**E8364BH85-03****S E R V I C E N O T E**Supersedes:  
NONE**E8364BH85 PNA Microwave Network Analyzer**

**A connector of the ribbon cable (Agilent part number 8120-8409) that joins the front panel display to the front panel interface board can loosen, causing a display failure, unless a new bracket is installed. Because the failure rate has been very low, it is recommended that the bracket be installed only when there is an additional reason to remove the PNA front panel.**

SERVICE NOTE CLASSIFICATION:		
<b>MODIFICATION AVAILABLE</b>		
ACTION CATEGORY::	AGREEABLE TIME	PERFORMANCE ENHANCEMENT X SERVICE / RELIABILITY ENHANCEMENT
LOCATION CATEGORY:	CUSTOMER INSTALLABLE ON-SITE X SERVICE CENTER	AVAILABILITY: Product's support life.
AUTHOR: MF		PRODUCT LINE: WN
ADDITIONAL INFORMATION: This Service Note applies to the following PNA models: E8356/7/8A, N3381/2/3A, E8801/2/3A, E8361/2/3/4A, E8362/3/4B, E8362/3/4BH85, and N5230A.

**Figure 1:** A3 Front Panel Interface Board Assy without the Bracket

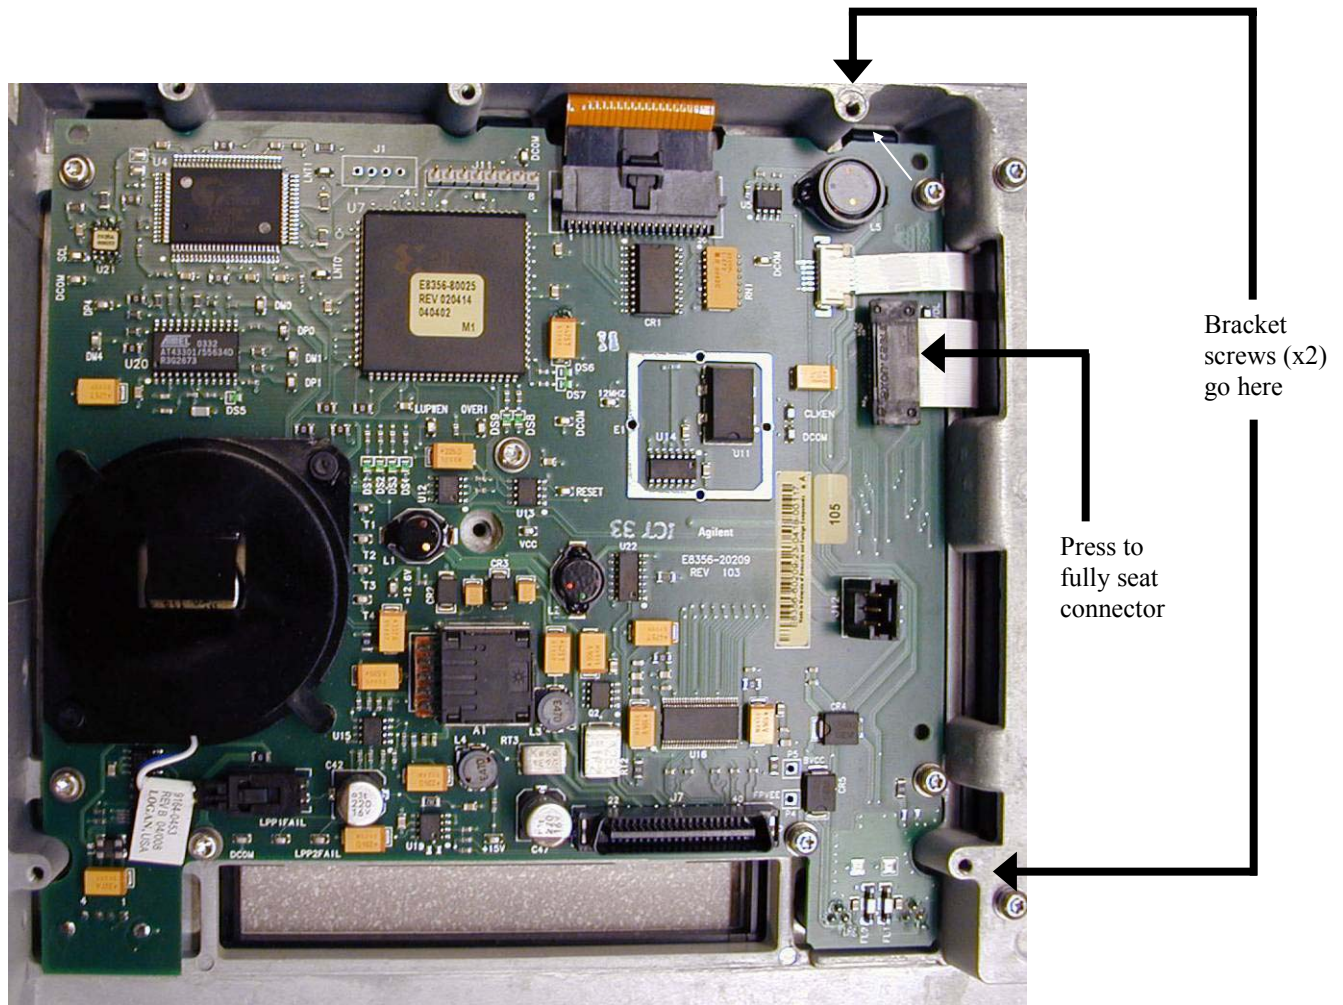
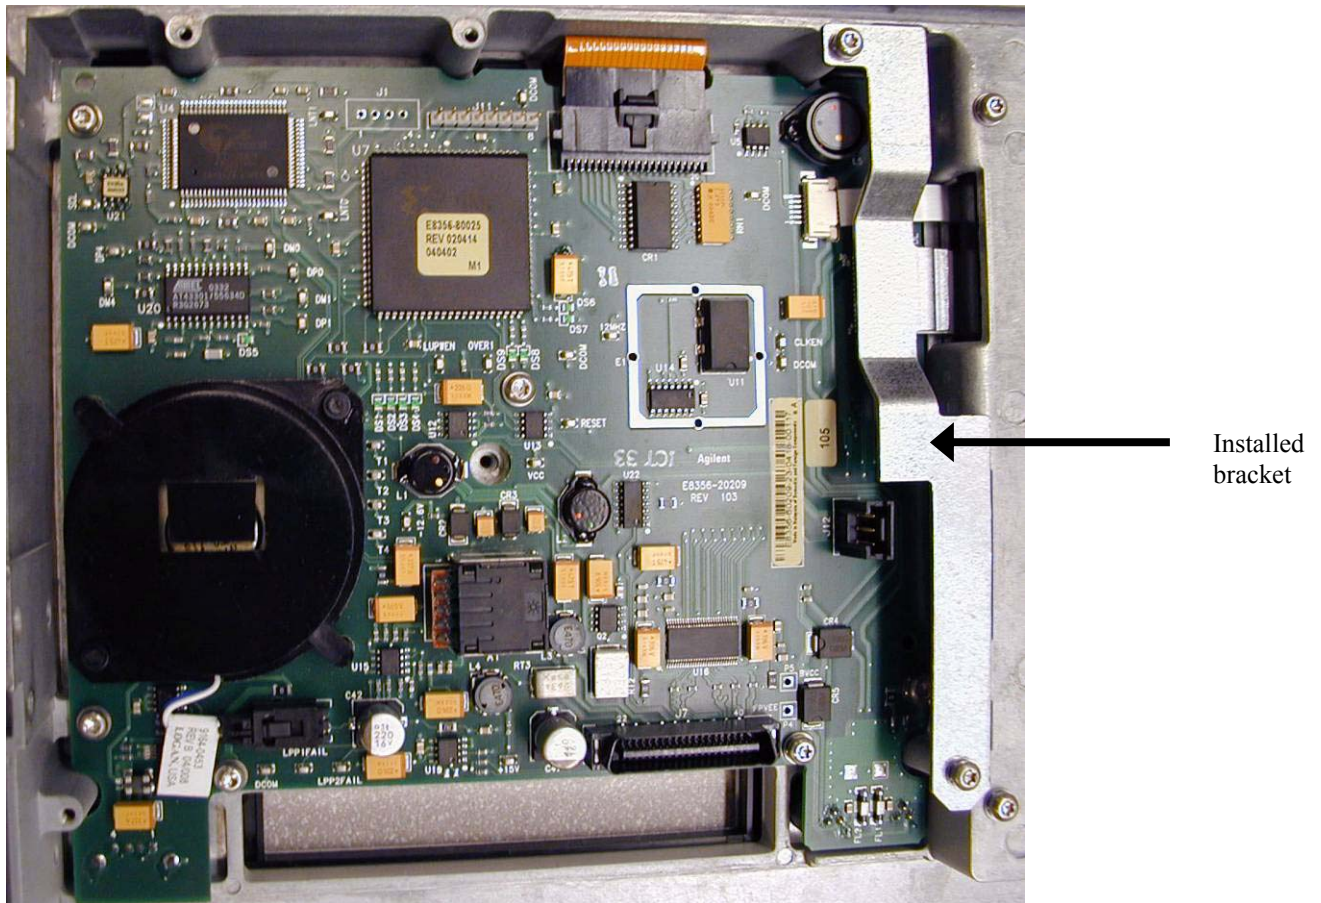
A connector of the ribbon cable (Agilent part number 8120-8409) that joins the front panel display to the front panel interface board can loosen, causing a display failure, unless a new bracket is installed. Because the failure rate has been very low, it is recommended that the bracket be installed only when there is an additional reason to remove the PNA front panel.

1. Refer to Figure 1 in this document:
  - Press down firmly on the ribbon cable's black connector.
  - Locate the two tapped holes for the bracket screws.
2. As shown in Figure 2 in this document, position the bracket so that its holes line-up with the two holes you located in the previous step.
3. Hand-start the two screws, and then torque both to 9 in-lbs.
4. Reinstall the PNA Front Panel by following the Service Guide instructions in the "Replacement Procedure." This is located on the same page as the "Removal Procedure" used previously in step 7.
